Response to Referee Comment on "Exploring hydrological similarity during soil moisture recession periods using time dependent variograms"

by Mälicke et al.

November 2018

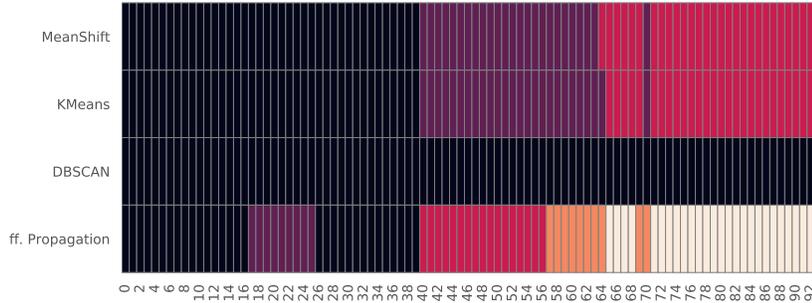
As suggested by the referee, we tested different common clustering algorithms and ran the clustering on the actual data. The resulting comparison presented below and how we justify the selection of *MeanShift* will be added to the manuscript's method section. Note that a variogram is viewed as a coordinate tuple in $\mathbb{R}^6$ and therefore cannot be plotted easily. We rather visualized the classification result of four different clustering algorithms (Figure 1). This shows that *MeanShift* and *KMeans* result in the same classification. The main downside of *KMeans* is that the number of clusters has to be predefined, which makes it unsuitable for the study. *DBSCAN* is, like *MeanShift*, a density based algorithm. It failed to find more than one cluster in all investigated cases, most likely because our variograms are of rather high dimensionality ($\mathbb{R}^6$) compared to the sample size of 92 (variograms). *Affinity Propagation* sounded promising as it is based on the idea of finding the set of n most representative instances within the sample. The *Affinity Propagation* is mainly controlled by the *damping factor*, which influences the calculation of similarity between two instances. Like the bandwidth parameter for *MeanShift*, different *damping factors* can result in just one or as many clusters as sample size. However, we preferred the

MeanShift as the bandwidth is directly linked to the Euclidean distance between two coordinates (variograms) in the sample and could therefore be inferred from the variogram distribution. The *damping factor*, on the other hand, seems more like a dimensionless calibration factor tweaking the results and therefore it would be way more complicated to select an overall justifiable value.
